**WACONIA PLANNING COMMISSION MEETING AGENDA**

- 1. CALL MEETING TO ORDER AND ROLL CALL**
- 2. ADOPT AGENDA**
- 3. APPROVAL OF MINUTES**
  - 1) February 5, 2026, Planning Commission Meeting Minutes
- 4. NEW BUSINESS**
  - 1) **PUBLIC HEARING – Woodland Trail Preliminary Plat, & PUD Zoning Request– 9350 Airport Road**

The City of Waconia staff have reviewed the proposed Preliminary Plat application for the Woodland Trail residential development drafted by Champion Engineering Services, Inc. dated December 20th, 2025, and provide the following review and comments:

**TREE PRESERVATION PLAN**  
 SHEET NO. 1 OF 28 SHEETS

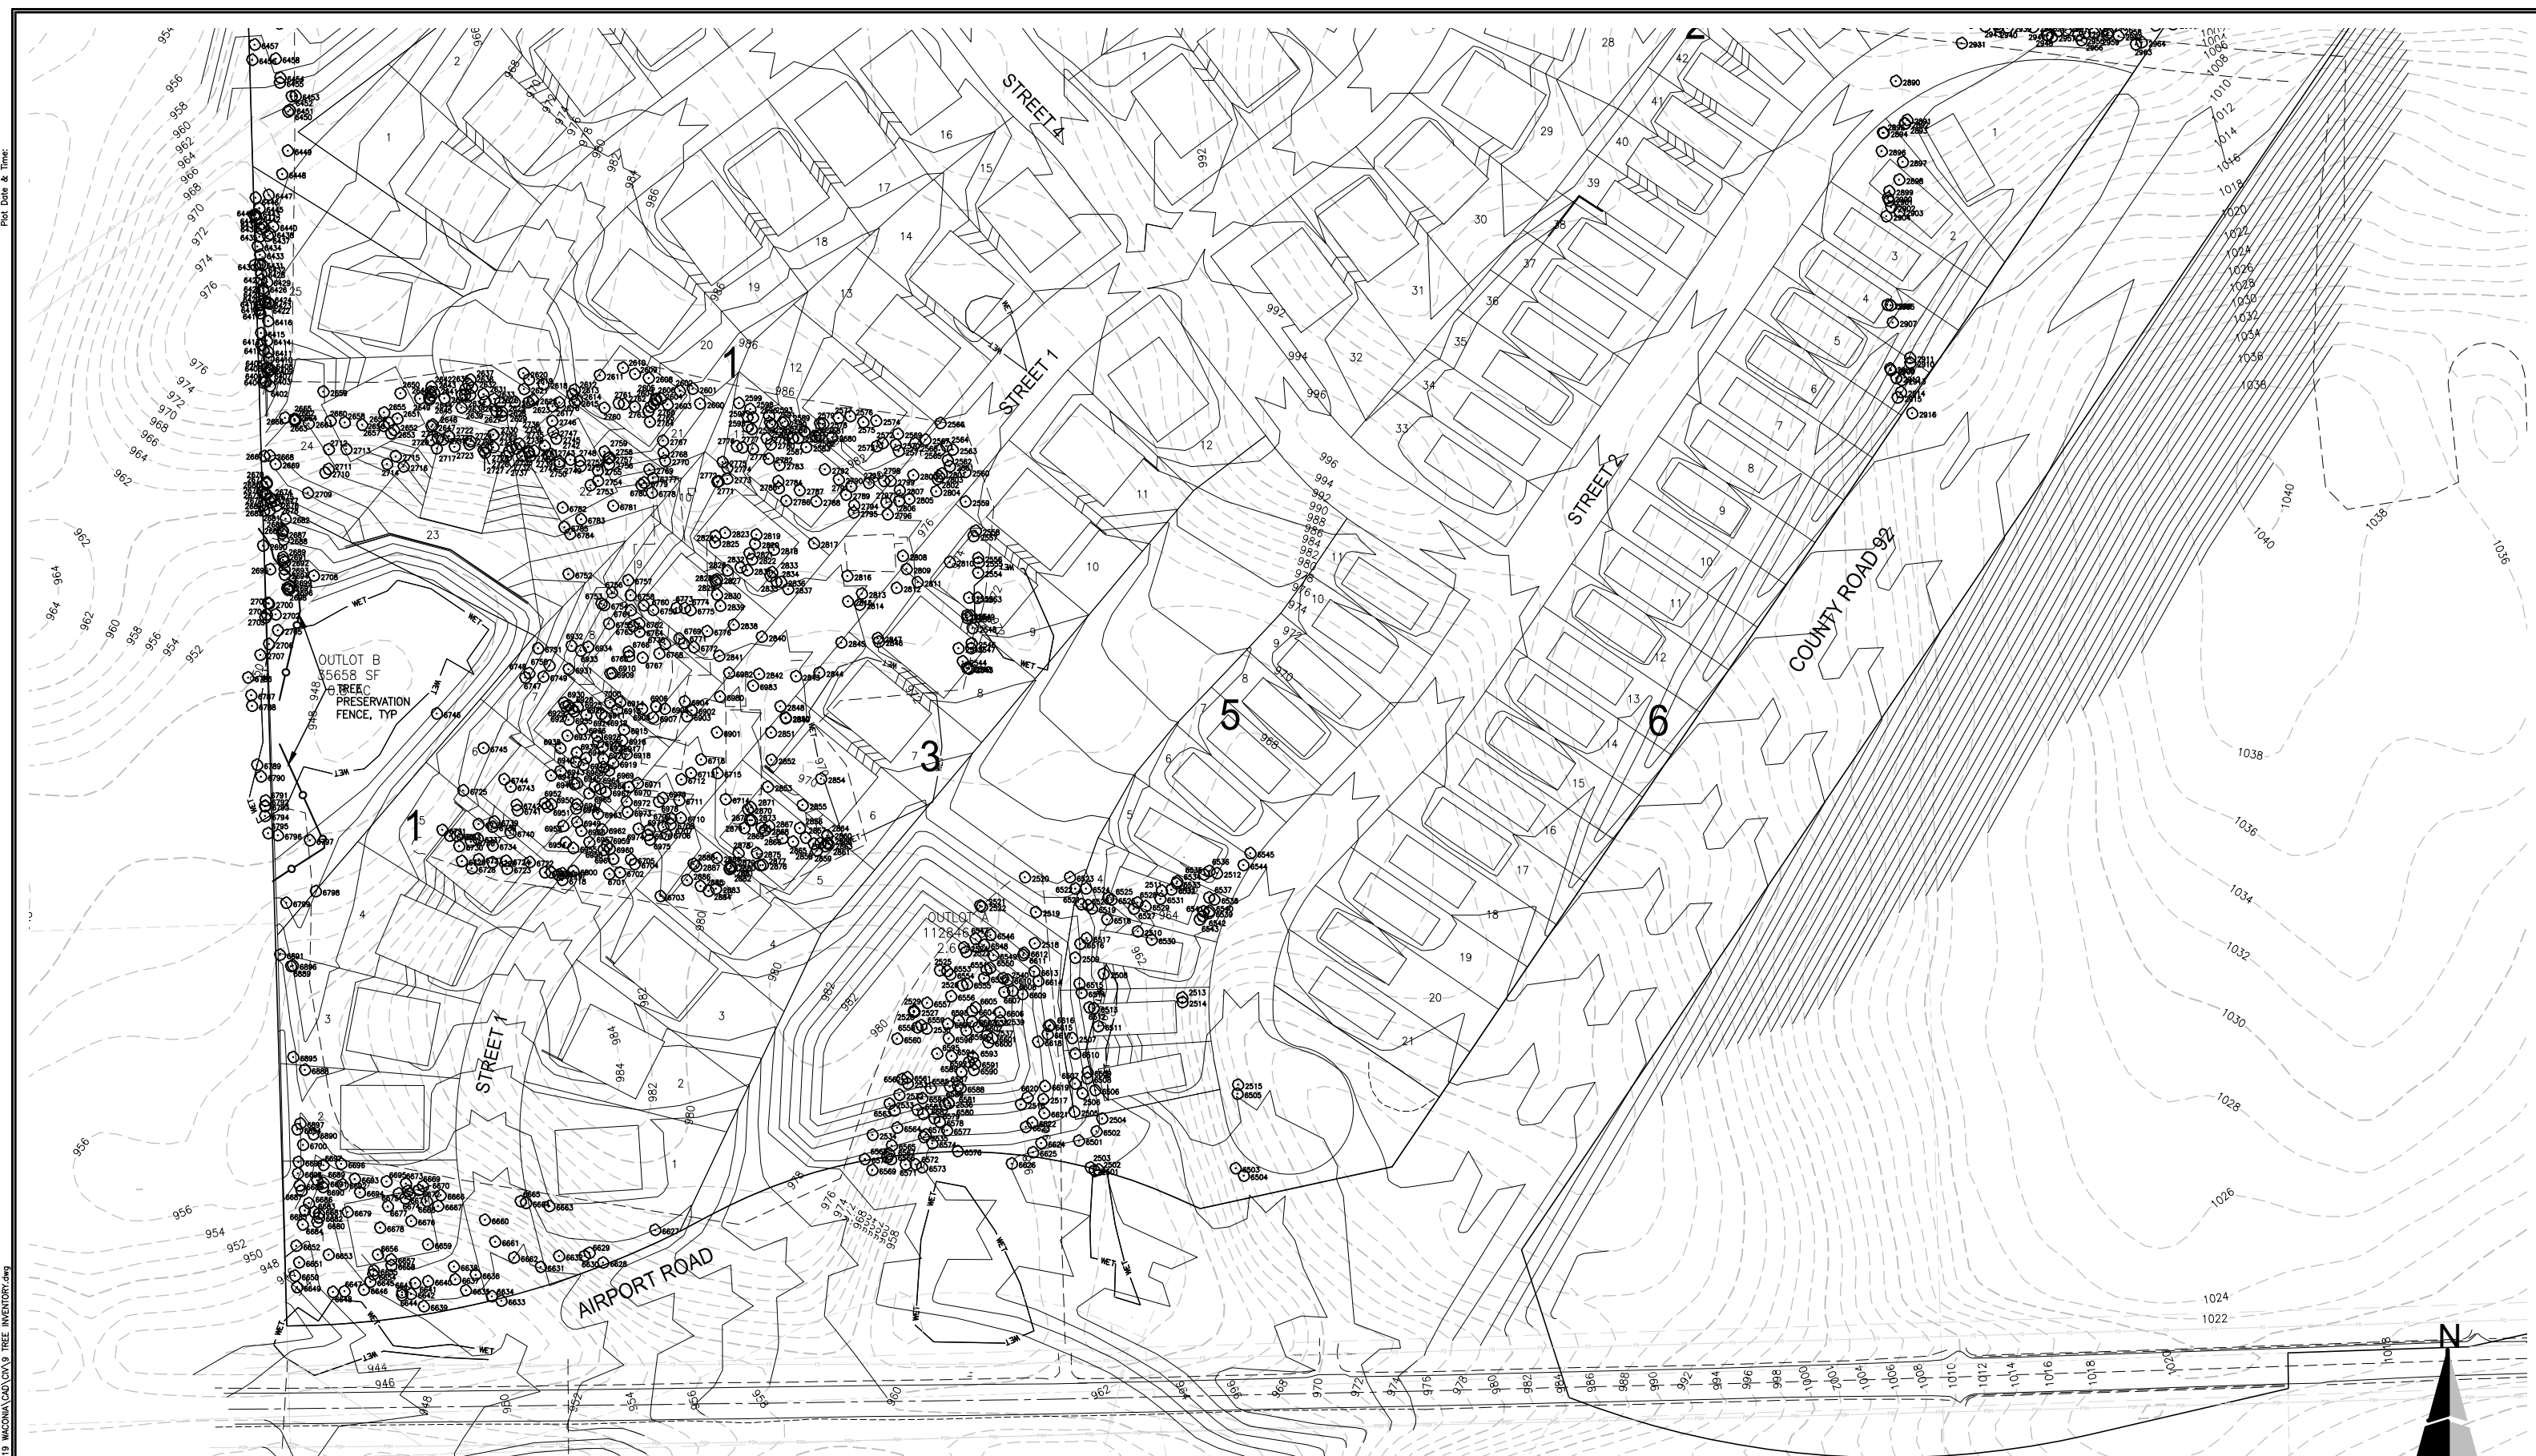
The applicant has provided an Overall Tree Preservation Plan consistent with City Ordinance requirements. The applicant and City staff have been working on identifying the application of the tree replacement rule in relation to the existing significant trees on site. The planned removal exceeds the 30% allowance by City Code and staff intends to work with the applicant as part of the PUD request to apply the applicable tree restitution fee to other improvements to the public good which may include additional trail work, construction of portions of Airport Road, etc. The final tree restitution amount will not be calculated until staff can get on site and determine which trees can be removed from the count and which

trees are required to be replaced. As such, staff is recommending a condition of approval requiring verification of significant tree exceptions in the tree restitution plan, which will inform the final restitution amount required by City Code. Additionally, the applicant shall work with City staff to apply all, or a portion of, the tree restitution fee to other applicable improvements in and around the project that would provide public benefit.

17. Staff shall review the tree preservation and tree restitution requirements in association with an on site inspection to determine the applicable amount of trees and or cash in lieu payment is appropriate. Any cash payment in lieu, by review and approval of city staff, may be applied to other applicable improvements in and around the project that would provide public benefit.
